HumeLink

Amendment Report

Rev 0

May 2024

FIGURE 3-3a: Changes to worker accommodation facilities

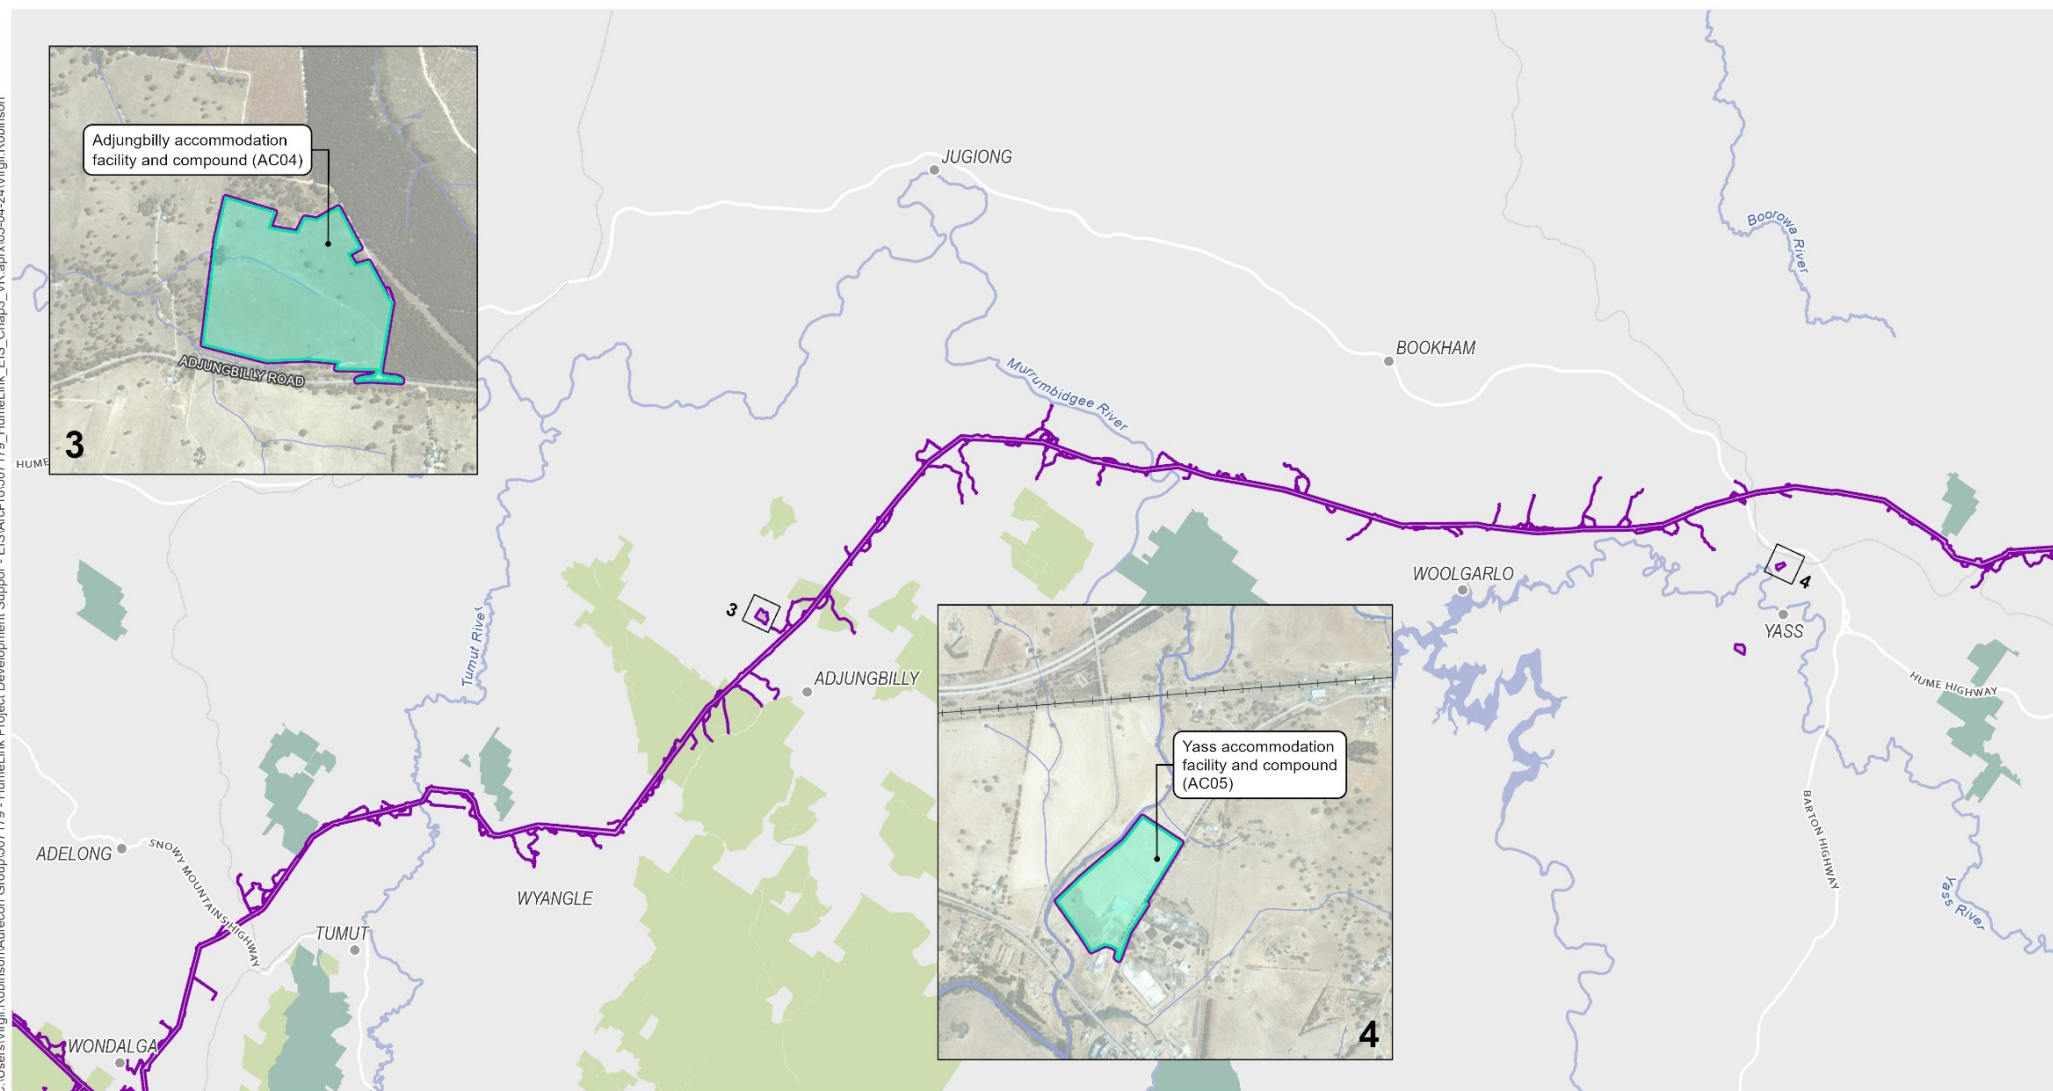
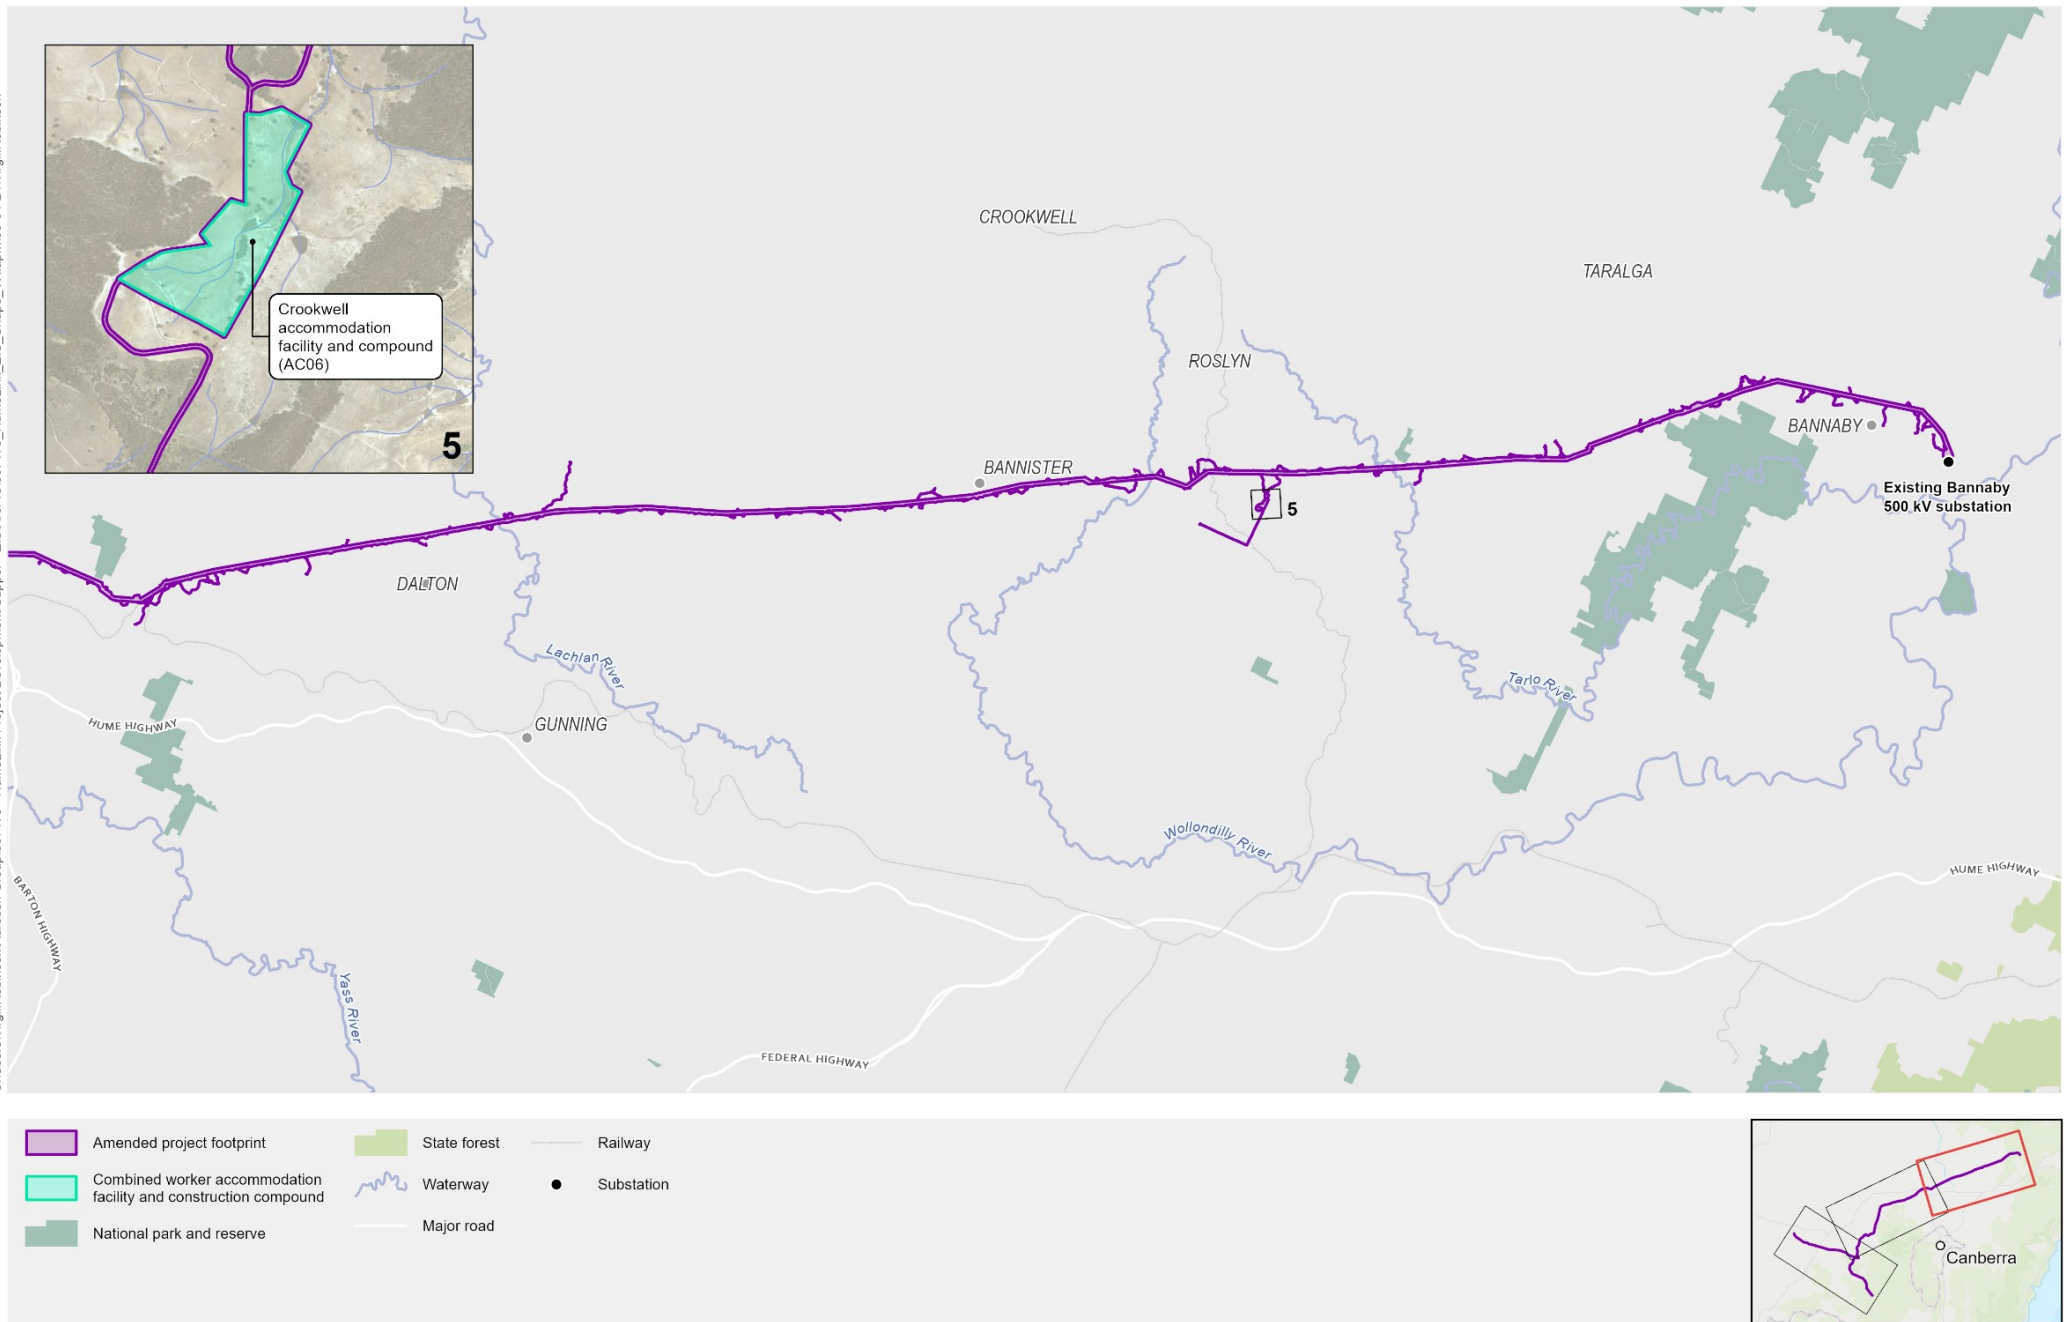
The new temporary worker accommodation facilities and construction compounds are described in Table 3-3 and shown in Figure 3-3. Further detail is provided in Appendix A (Updated project description).
